**Horse Creek Quarry
Stream and Wetland Delineation**

3 Tees, LLC
Proposed Horse Creek Limestone Quarry
Horse Creek, Sullivan County, Tennessee
Stream and Wetland Delineation

From: Dan Murray <Dan.Murray@tn.gov>
Date: Mon, Dec 11, 2023 at 9:15 AM
Subject: RE: [EXTERNAL] 3 Tee application Hydrologic Determination for ARAP
NR23MS.016 & NPDES TN0070724
To: Cool Wood <coulwood1214@gmail.com>
CC: Daniel Lawrence <Daniel.Lawrence@tn.gov>, Bonnie Craighead
<Bonnie.Craighead@tn.gov>, Tina Robinson <Tina.A.Robinson@tn.gov>

Subject: 3 Tees Hydrologic Determination

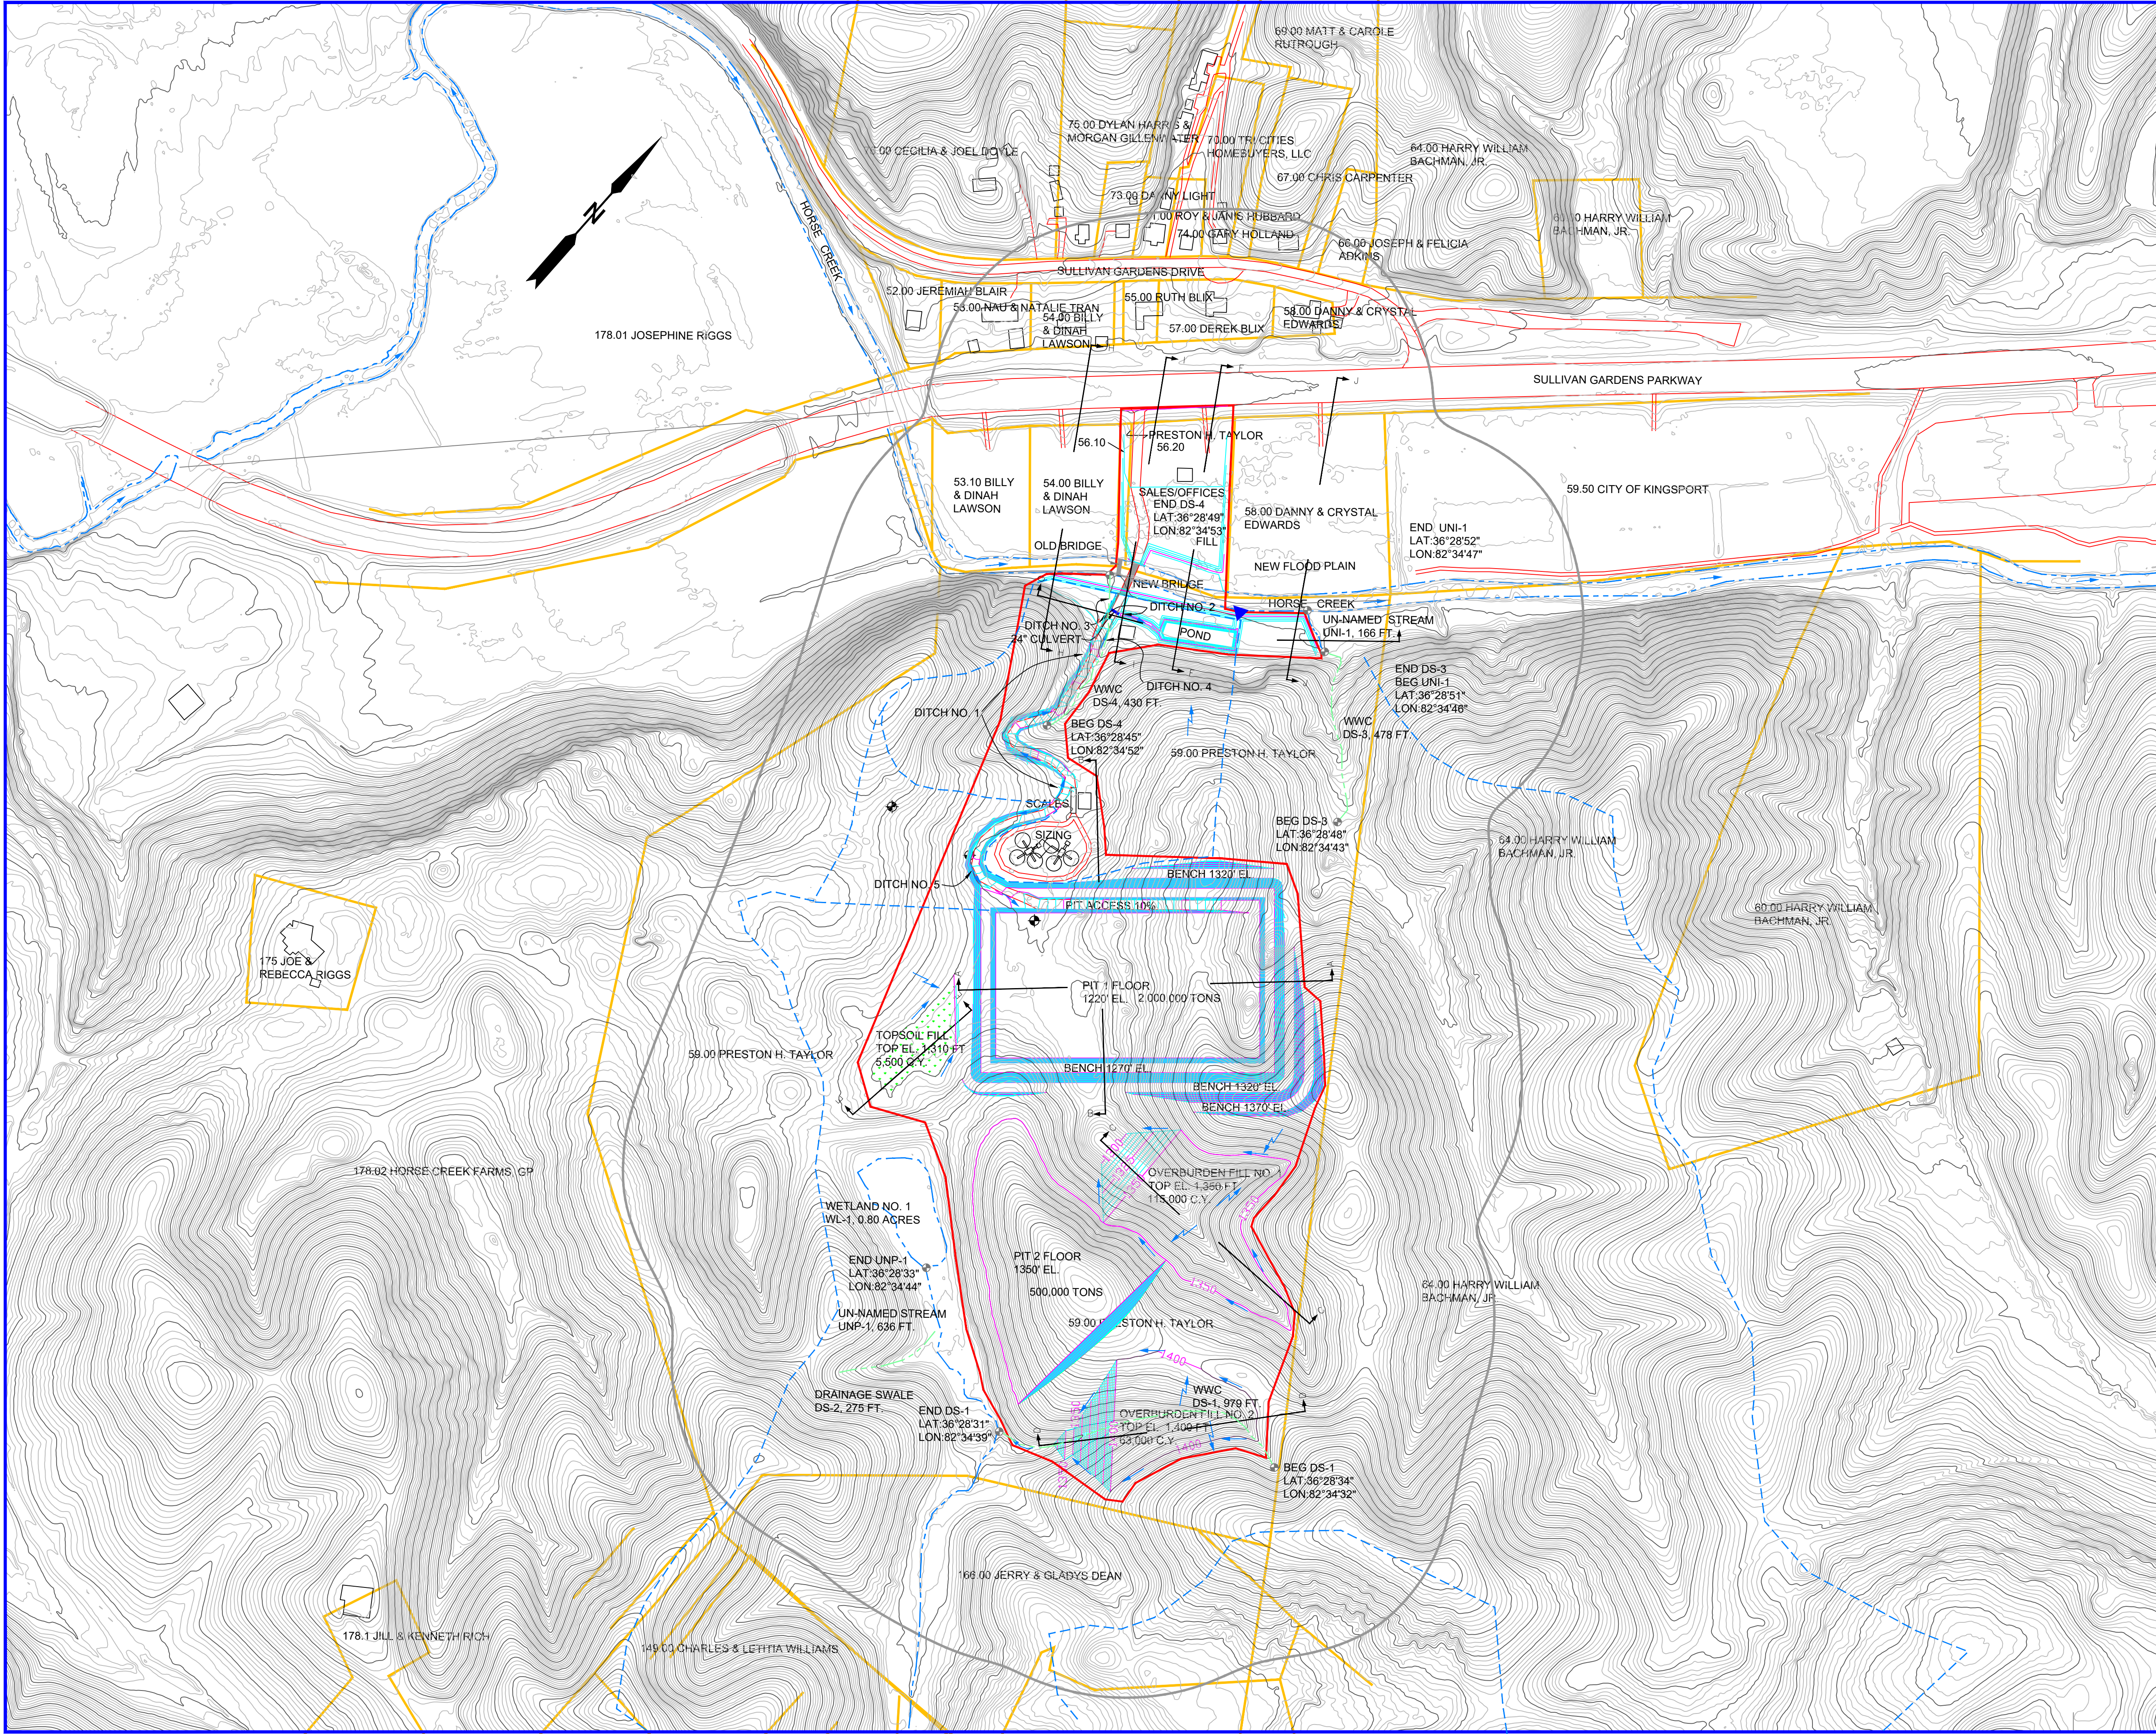
3. Identification of the starting point and ending point for each linear feature determined to be a wet weather conveyance must be provided on a map or within the body of the HD submittal. A point on the HD Field Data Sheet is not sufficient.

1. See attached letter from landowner.
2. See revised narrative.
3. See map for points.
4. See revised forms.
5. See included precipitation data.
6. Wetlands are often found along streams and the area was investigated for such. No wetlands were located other than WL-1 previously noted.
